HISTORIC PRESERVATION COMMISSION Minutes

A. Rick Folger representing Nancy Costa – 25 Ross Street – Windows and Doors

Certificate of Appropriateness Application 25 Ross Street

Request #1: Replace Five Basement Windows

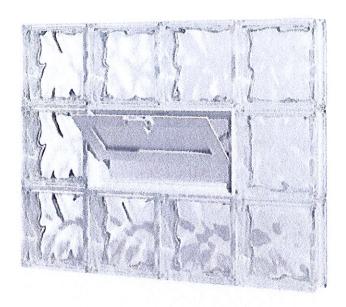
First item Mr. Folger presented was replacement of five basement windows. Ms. Siverling asked if any basement windows are visible from the street. Mr. Folger explained that with the configuration of the bushes you are unable to see them. He explained that there are three on the south side, one on the north side and one on the west side. Ms. Burkel asked if these are the only basement windows. Mr. Folger explained that they are because the front which is the east side has a porch. Ms. Burkel asked if the homeowner has a preference to the style of window. Mr. Folger answered that they do not. Ms. Burkel stated that she agreed with the security of the block windows. Ms. Barton explained that she liked the decora style block windows.

- Three are wood frame (in the house) and 2 are metal framed (in the attached garage).
- Locations: One on North side, 3 on South side, and 1 on West (rear) of house.
- Reason: Energy efficiency (all are in such bad condition that the seller had them completely stuffed with batts of insulation; glass in one of the metal windows is broken), usability for ventilation (no sump pump), and security all are located behind shrubs.

- 1.) Replace the five basement windows with Pittsburgh Corning Guardwise Vented Block Windows in Decora pattern;
- 2.) Add six missing storm windows on the second floor over the garage with Weatherstar Aluminum Storm Windows to be painted to match the rest of the trim on the house;

Request #2: Add missing storm windows on second floor to:

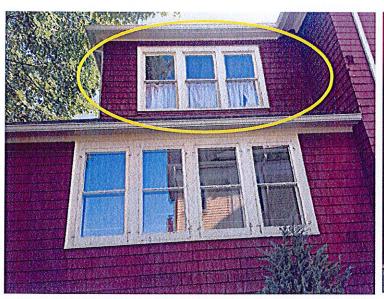
Next item that Mr. Folger presented was adding storm windows to the windows that don't have them. Mr. Folger stated that most of the other windows already have an aluminum storm windows. He would like to save the original wood windows but these storm windows would make it more efficient. Three of the proposed windows are located in the rear above the attached garage. Ms. Burkel asked if he could paint the trim to match the rest of the trim on the house. Mr. Folger was unsure if the aluminum would be paintable and Ms. Burkel stated it should be. Mr. Folger stated as long as it is possible that he will paint it. Mr. Folger stated that these storm windows will be functional and have screens in them.

A. Six double-hung single-pane wood windows on sleeping porch over garage (currently unconditioned space). I would like to add storm windows to prevent further deterioration to windows and casings. I plan to repair windows and finish room in the future.

B: Fixed 8-light bedroom window

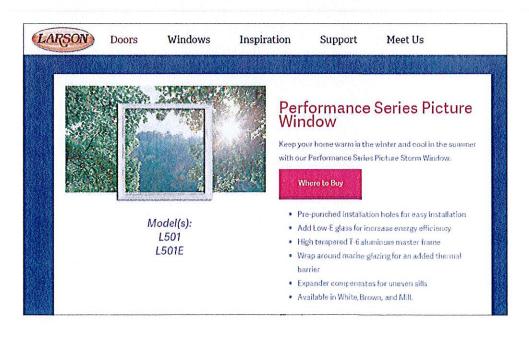
Mr. Folger would also like the 8 lite window to get replaced with a storm window that is not functional. This would be one solid glass window.

- 3.) Add to the fixed 8 lite window a Larson Performance Series Picture Storm window that is painted to match;
- 4.) Garage door will be replaced with four ReliaBilt Steel French door or equivalent will be submitted later. Both sides of the doors will be framed in with wood and covered with wood shingles painted to match the rest of the house. Doorframe will be painted the same cream color to match the rest of the exterior trim;

Request #3: Replace attached garage door

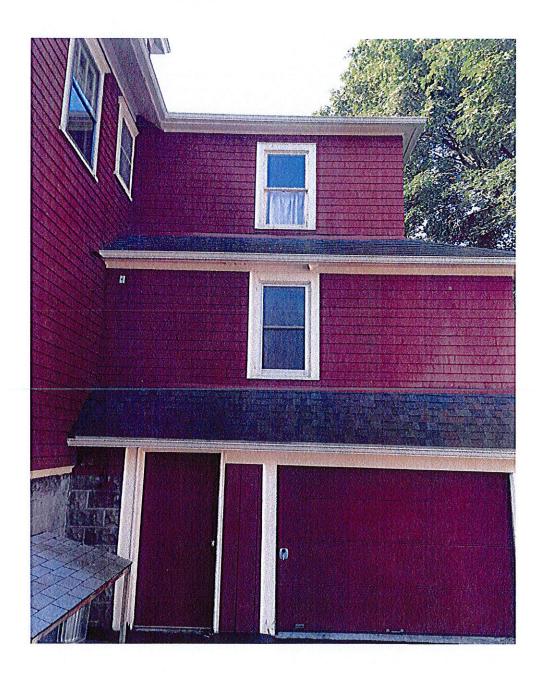
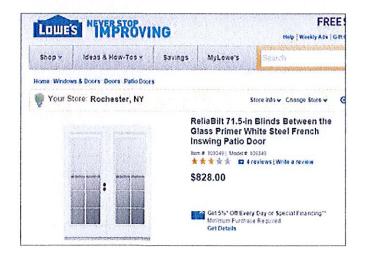
Mr. Folger presented the garage overhead door and man door to be replaced with swinging patio doors. Ms. Siverling asked if they would be steel doors. Mr. Folger stated that they are.

- Structural support pole in center of existing attached garage makes space unusable to garage vehicles.
- Current garage door would need major investment: opener needs replacing, track is broken, and door is not insulated especially important as room above is living space.
- Adjoining man door is not secure and shows evidence of past security issues (one incident since closing). Door inside garage leads to basement.
- Note area is not visible from street.

- One set of inswing french patio doors would provide clearance to move large pieces of furniture in and out. The outside pair would be fixed.
- Blinds between the glass would provide privacy and security.
- Space on both sides would be framed in with wood and covered with wood shingles painted red to match the body color of the rest of the house.
- Door frames would be painted the same cream color as rest of exterior trim.
- My understanding is that this section of the driveway was previously covered with brick pavers and the plan is to eventually bring these back.
